Re: Formal Dispute Resolution - Statement of Position
Motor Wheel Disposal Site

Settling Defendants - Statement of Position Motor Wheel Disposal Site - May 11, 1999

Project Reference: #5104
MOTOR WHEEL SITE DISPOSAL SITE CLOSURE
LANSING, MICHIGAN

Figure 8: Predicted ammonia plume separation after 7 years of reduced summer pumping with a total Zone 1 pumping rate of 77 GPM (October to June)

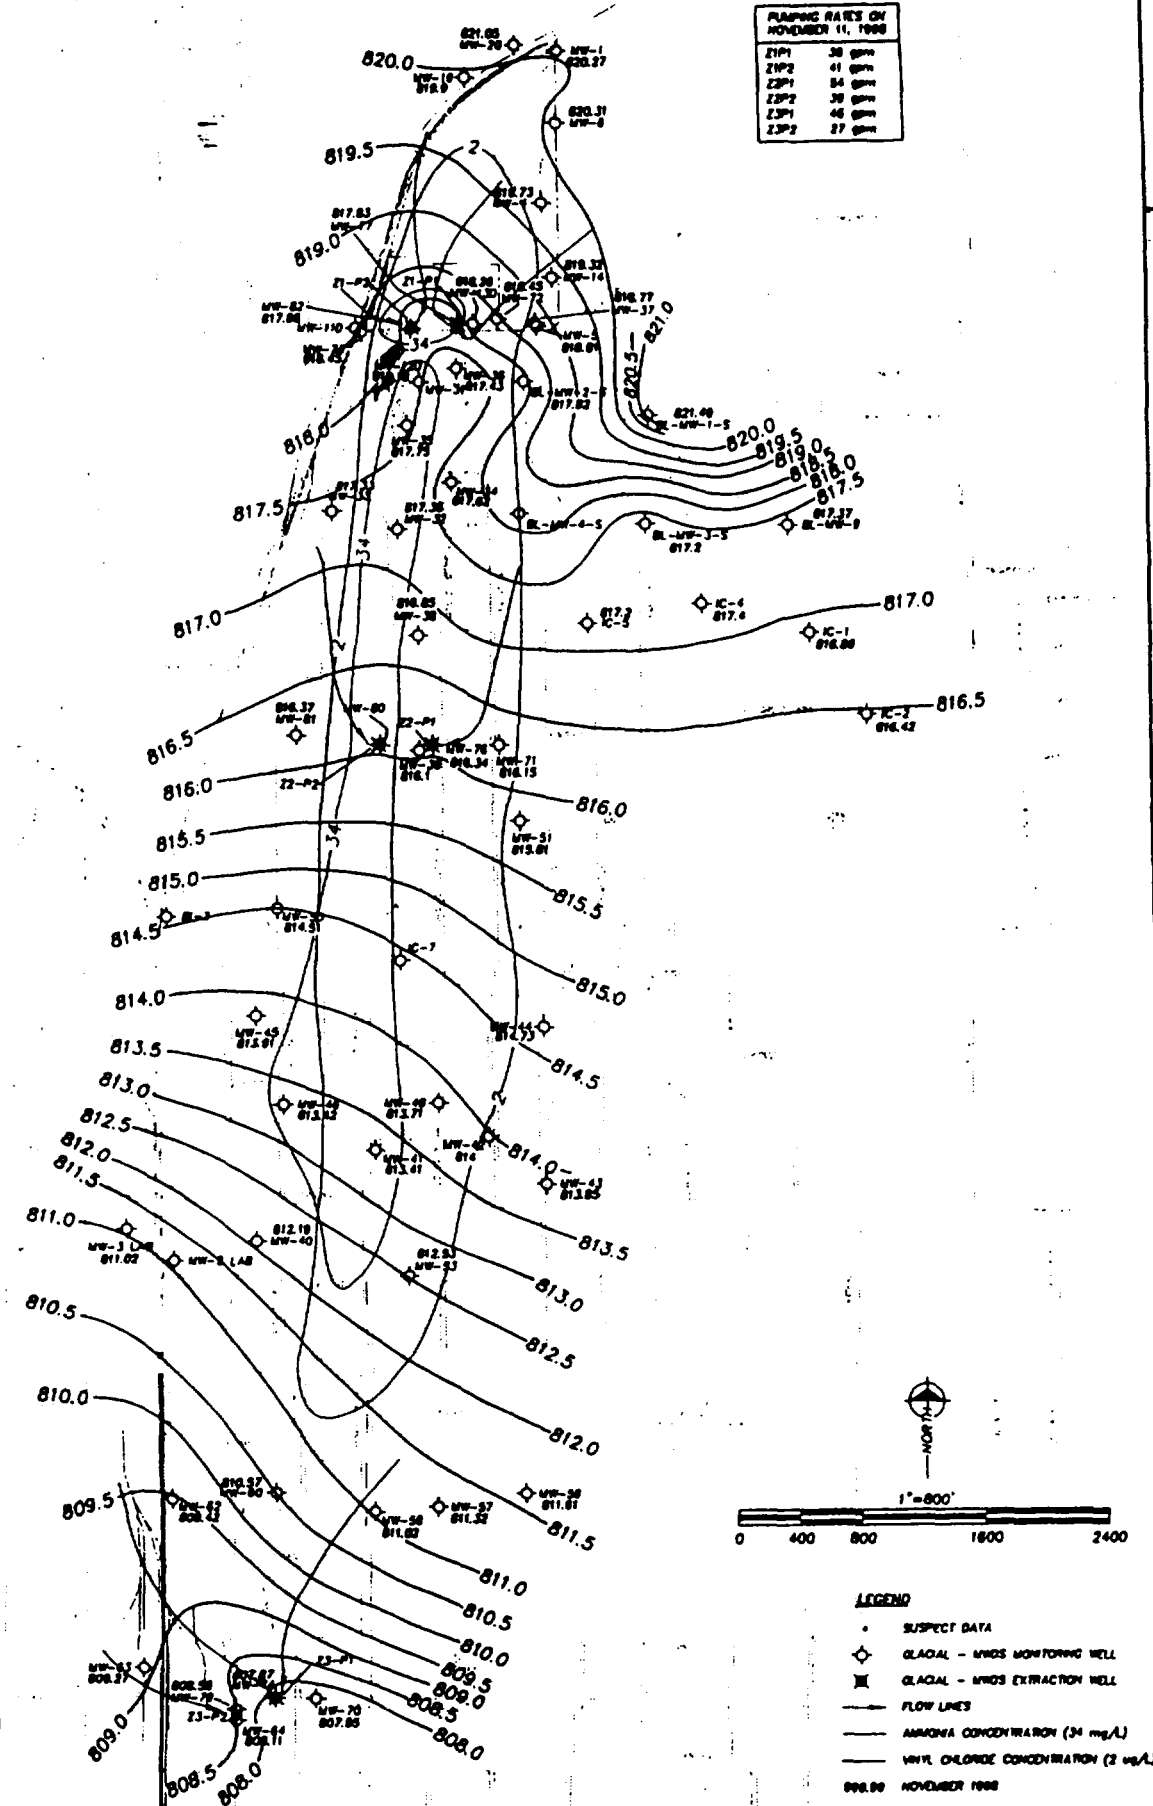
All of these simulations applied the design pumping rates for these wells, 90 GPM for Z1P1 and Z1P2 combined. While our goal is to obtain this pumping rate, the recent Zone 1 pumping rate since the fall of 1998 has averaged 77 GPM. As shown in Figure 8, ammonia plume separation is predicted to occur in seven years with a total Zone 1 pumping rate of 77 GPM (October to June). This is within the range of plume separation times achieved under the 90 GPM pumping scenarios simulated (6-8 years). Under all sensitivity scenarios tested with the conservative parameters outlined above, including a more representative pumping rate that will continue increasing, plume separation down gradient of Zone 1 is predicted.

Figure 10: Difference in observed concentrations between the Glacial and Saginaw Aquifers.

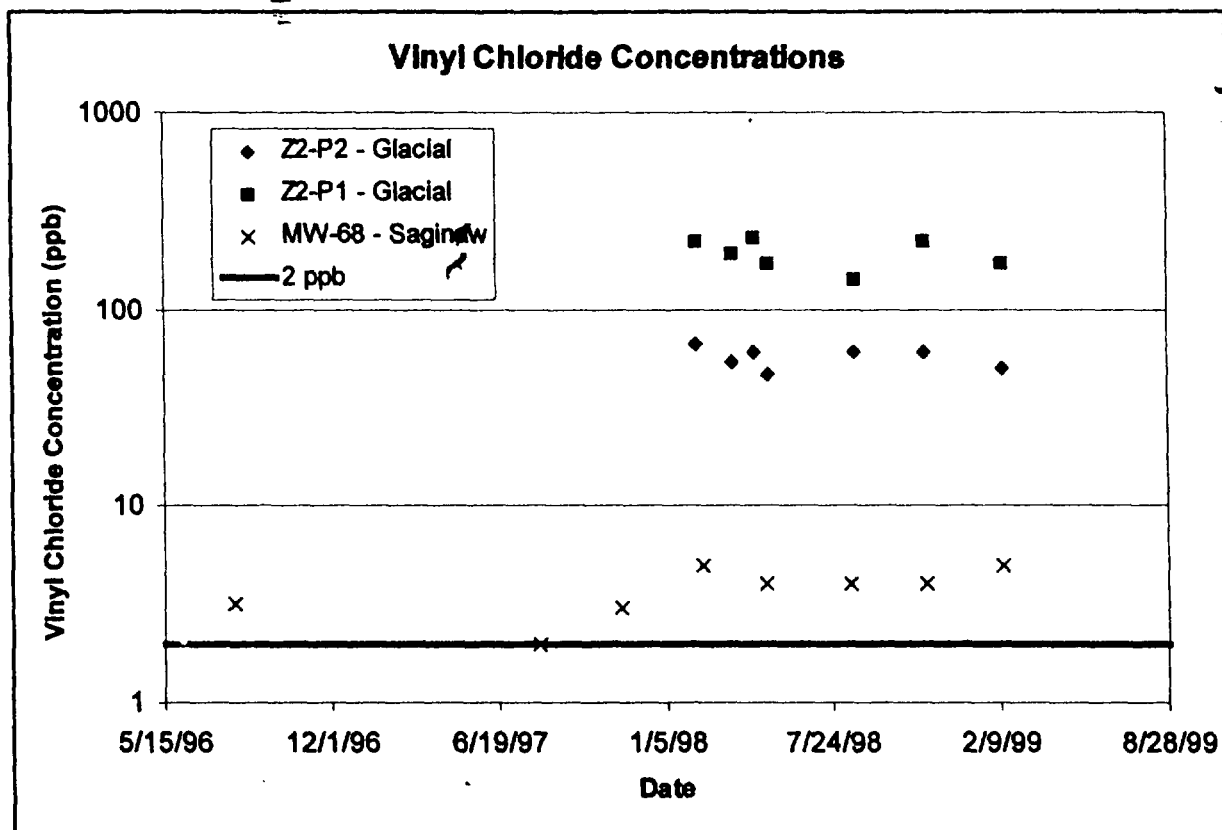
The available data shows that the level of vinyl chloride in the Saginaw is more than one order of magnitude less than that observed at the Zone 2 pumping wells (see Figure 10) due to mass removal at the Zone 2 extraction wells. We recognize that under any Zone 2 operational scenario some vinyl chloride will migrate to the Saginaw Aquifer. However, upon entering the Saginaw Aquifer vinyl chloride is observed to migrate northward, towards SEW-1 and SEW-2 and is therefore within the capture zone of the extraction system. No increase in the horizontal or vertical extent of the vinyl chloride plume in the Saginaw Aquifer will result from the reduction of summer pumping.

Figure 11: Simulated hydraulic gradient near Zone 1 Extraction wells in WHI Model

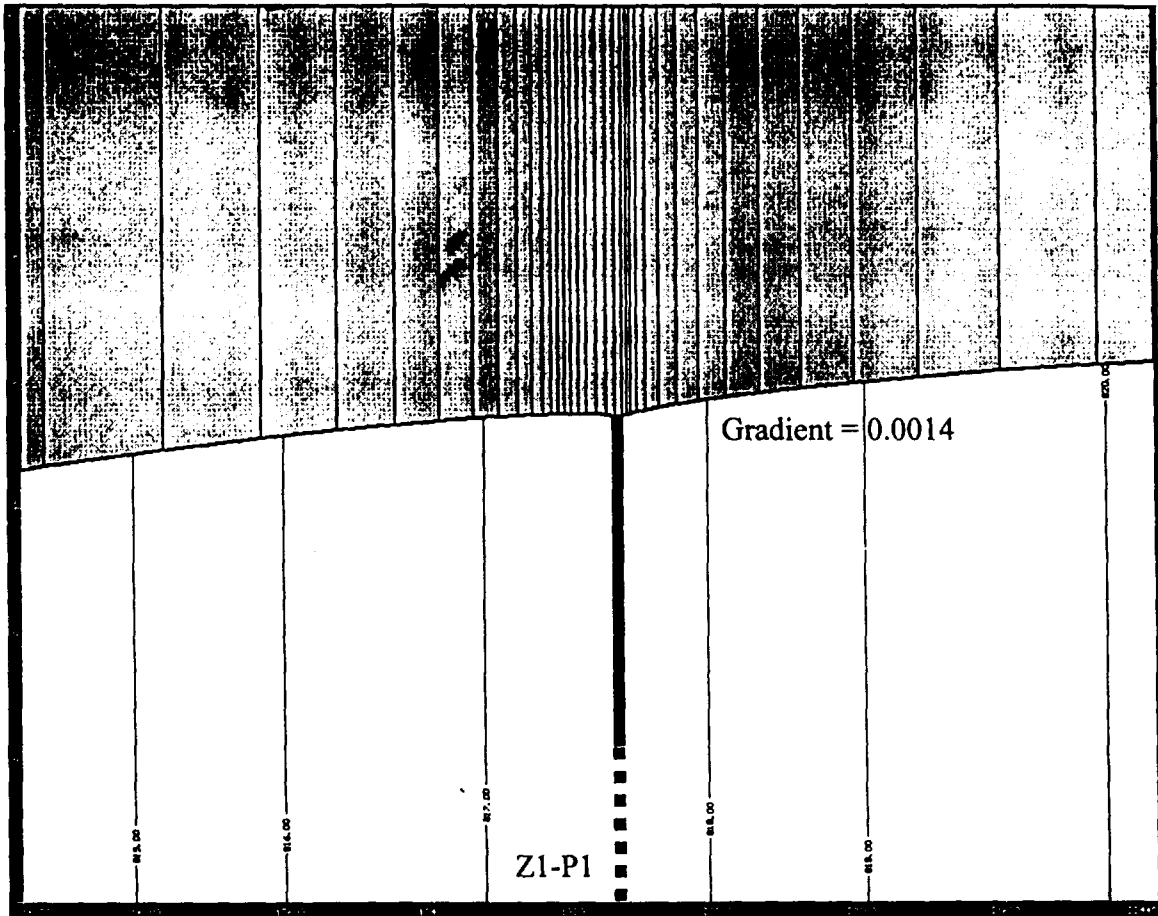
While the overall gradient across the WHI model domain was established as 0.001, the effective gradient at the Zone 1 pumping wells was 0.0014 (base case simulation), due to the effects of pumping and areal recharge (see Figure 11). The gradient suggested above, 0.0023 ft/ft, is not a reasonable value since it was derived from schematic watertable contours from Figure 25 of Sharp and WHI (1998). As a result of the installed landfill cap, there is a lack of monitoring wells to the north of Zone 1 such that only schematic watertable contours are feasible in that area.
